Appl. No. 10/046,066

AQUA-005

Amdt. Dated October 29, 2004

Reply to Office Action of July 29, 2004

FIG. 2C

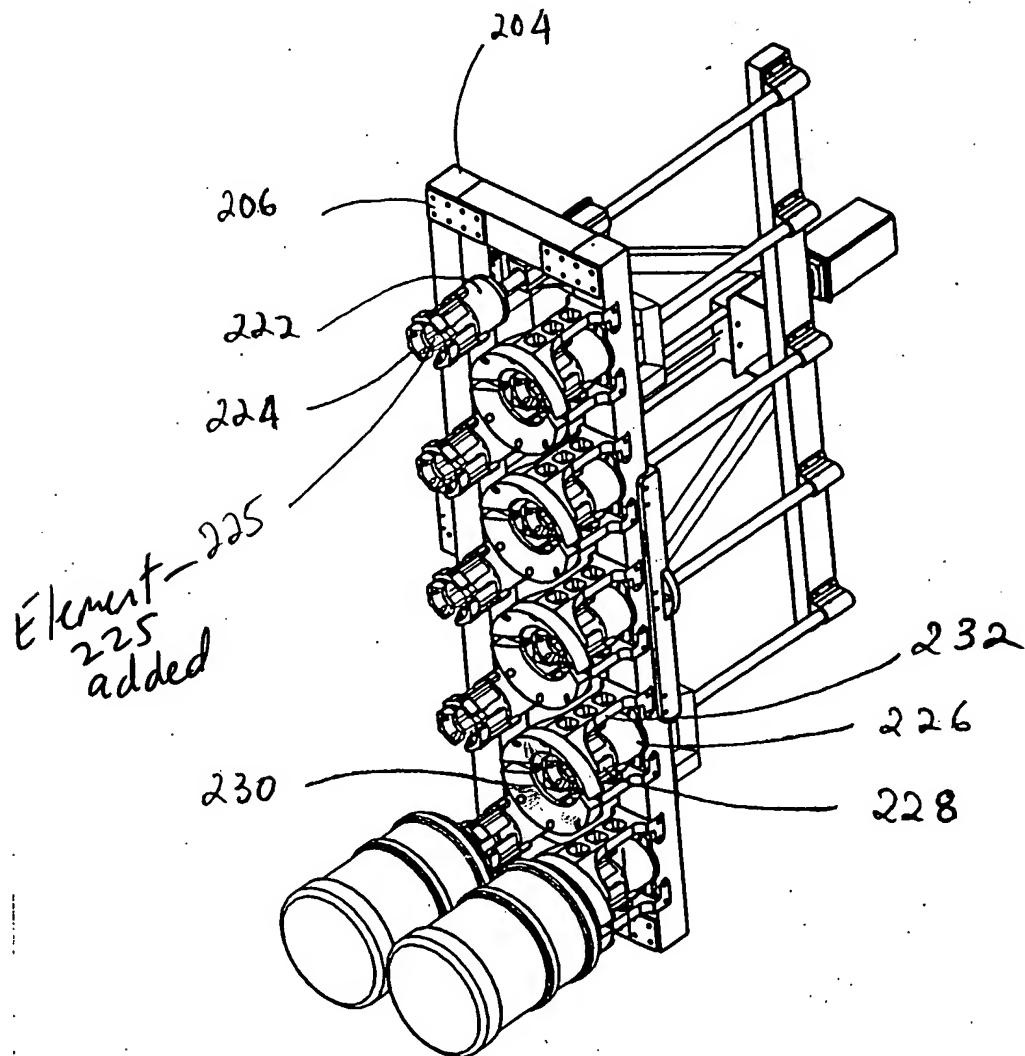
The drawings were objected to pursuant to 37 CFR 1.83 (a) for not showing the following claimed elements: the “pressure sensor”; the “interface”; and a “motorized base”.

Fig. 2c has been amended to show the pressure sensor (225). The specification has previously been amended to recite the correct reference number for the pressure sensor.

FIG. 3

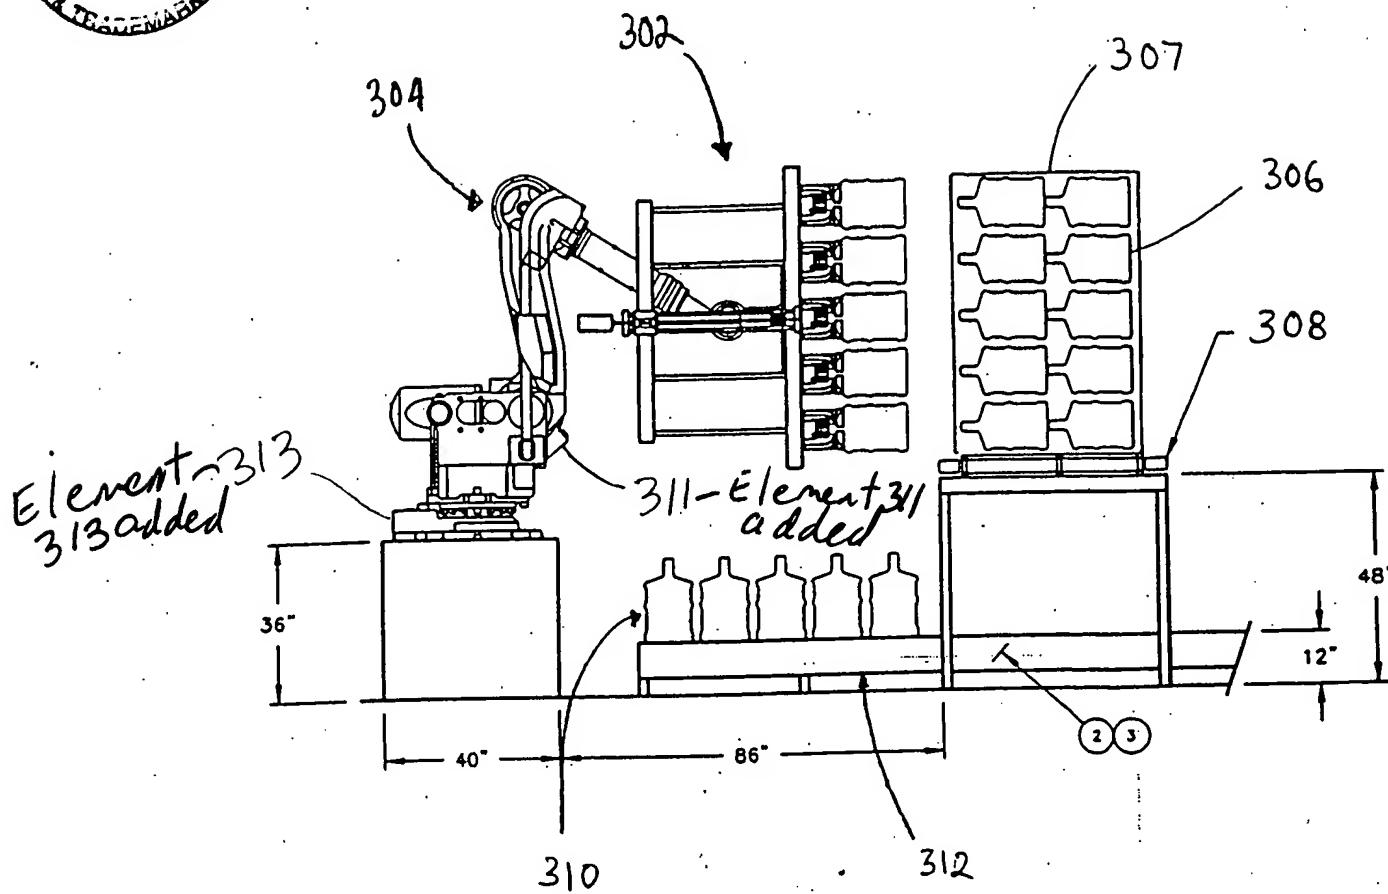
With regard to claim 19 and its dependents, the Examiner states that it “is not clearly understood as to how the ‘first container’ blocks the ‘second container’.” Although the Applicant respectfully disagrees, claim 19 has been amended to more particularly point out that a front container blocks a rear container because the rack has multiple bottles in each cell. Support for the claim amendments is found in paragraphs 19 and 20 of the specification and Fig. 3, among other places.

Fig. 3 has been amended to show the interface (311) and the motorized base (313). Replacement sheets for Figs. 2c and 3 are attached herewith.
